LICENSE No: 24-21362-01

CONTROL No.576320

SUBJECT: Request for Additional Information (RFAI) dated 2/23/12

Reply to RFAI in Conv Rec 2/23/12

AIR SAMPLING TRAIN

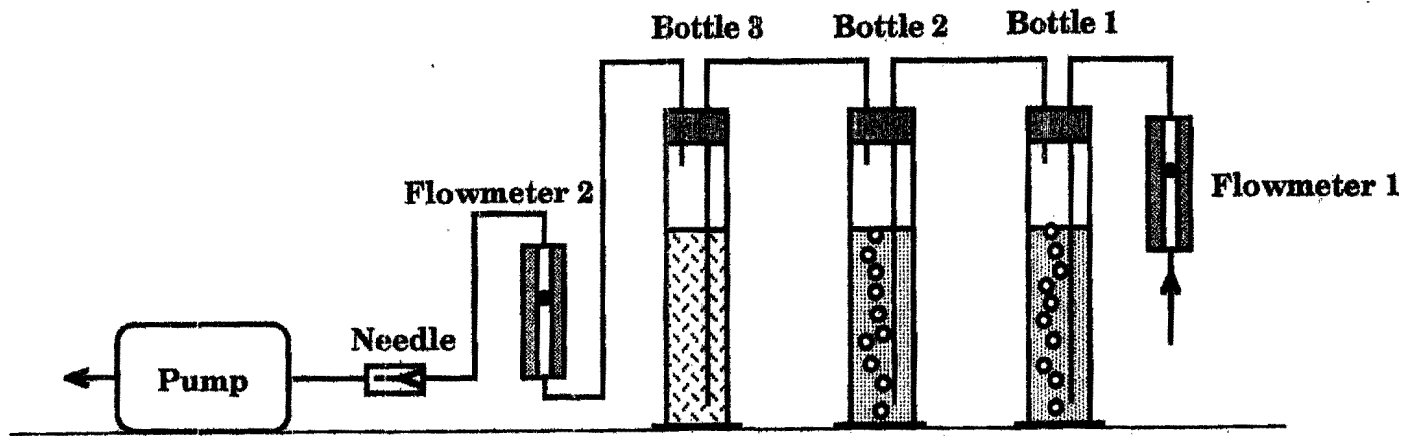
3 Describe the air effluent monitoring equipment. that will be installed to monitor air effluent from licensed operations in Building 300 Annex

The monitoring system presently used of Building 400 is now redundant as COMPLY is used to determine dose from Buildings 100/200/300. This system will be used to determine concentration discharged, and the results processed using COMPLY.

A sketch of the monitoring system is attached.
